CITY COUNCIL AGENDA ITEM

AGENDA ITEM: **201201766 (DRI)** - 4550, 4558, 4586, 4616 Roswell Road,
Applicant: JLB Partners, to rezone from A-1 (Apartment District) to
MIX (Mixed Use District) to allow a mixed-use development
(residential, office, and commercial), with a use permit and
concurrent variances

Agenda Item: **201201766 4550, 4558, 4586, & 4616 Roswell Road** a request to rezone the subject property from A-1 (Apartment Dwelling District) to MIX (Mixed Use District) with a use permit to exceed the district height, with a concurrent variance to allow 630 apartments, 90,000 square feet of retail/commercial/ restaurant and 30,000 feet of office.

Rezoning Petition No. 201201766

Recommended Improvements

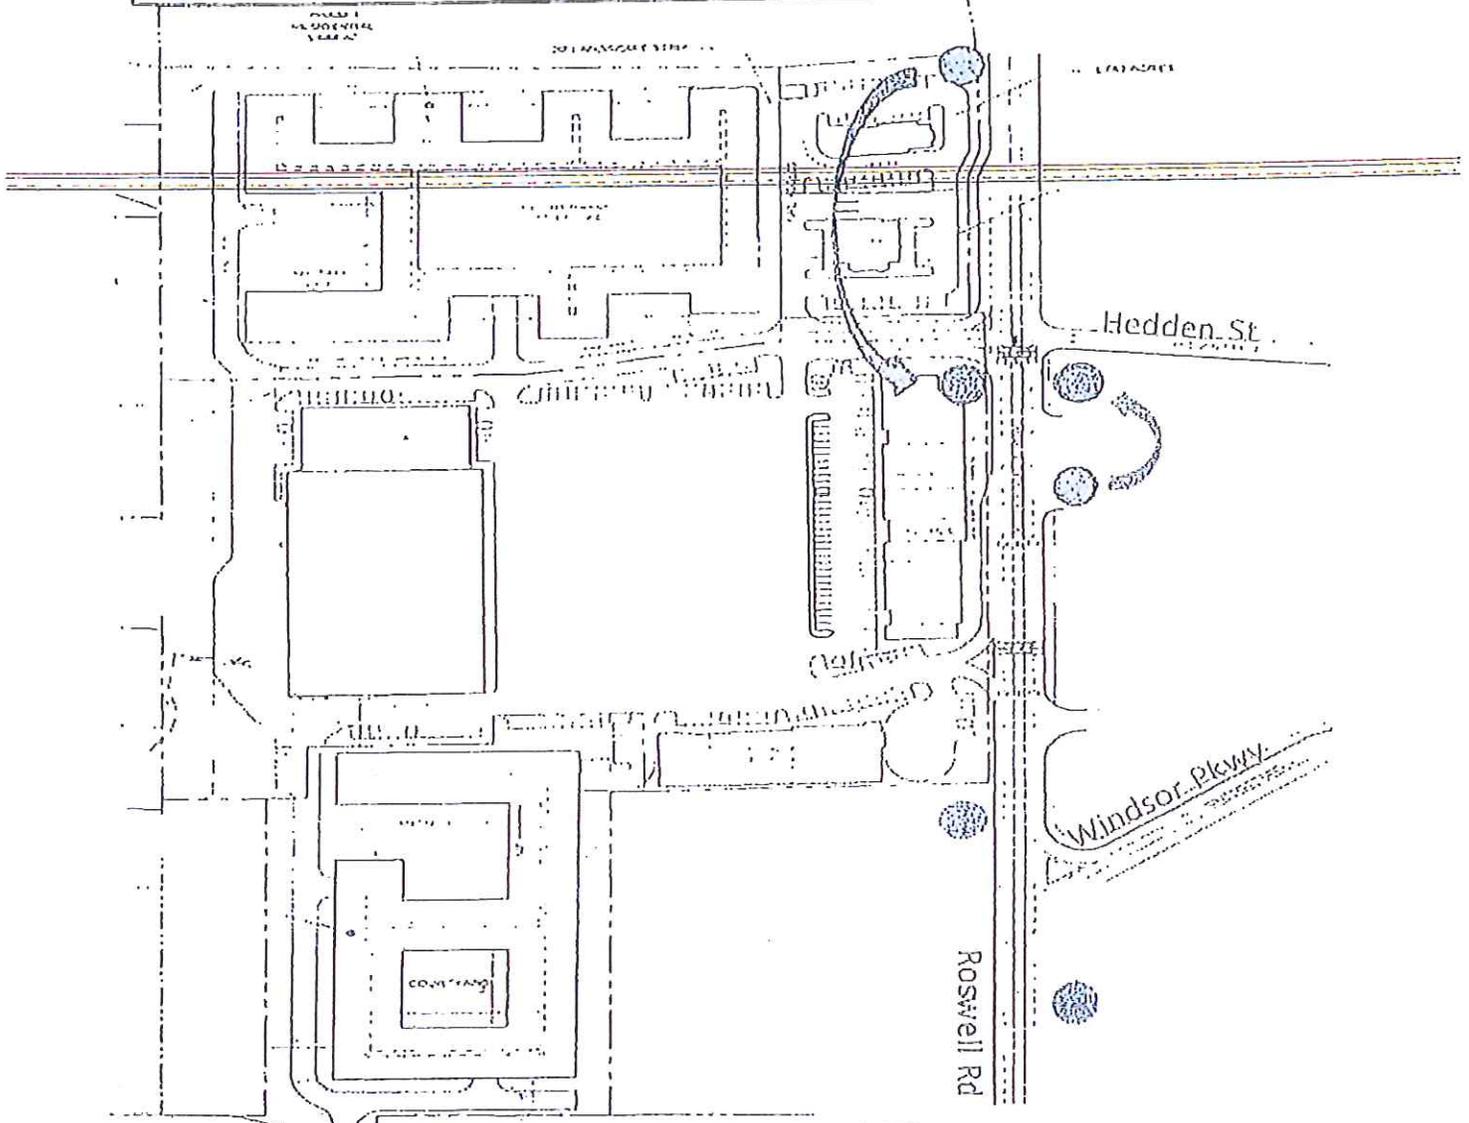
- All internal intersections must be a minimum 1/5 parcel depth per GDOT Driveway Manual from Roswell Road
- Provide an internal direct vehicular connection between access points on Roswell Road to access point on W. Wieuca Road
- A maximum of two site access points are allowed onto Roswell Road
- No outparcels shall have direct access onto Roswell Road
- Provide stub-outs to allow for future inter-parcel connections

- Provide bus shelter(s) at relocated MARTA bus stops near driveways, as approved by MARTA, for southbound and northbound transit riders along Roswell Road

- Provide crosswalks at all site driveways and intersections
- Provide pedestrian sidewalks along property frontage on Roswell Road
- Provide direct pedestrian connections between buildings
- Provide pedestrian paths for safe crossing of the parking field
- Provide bike racks throughout site
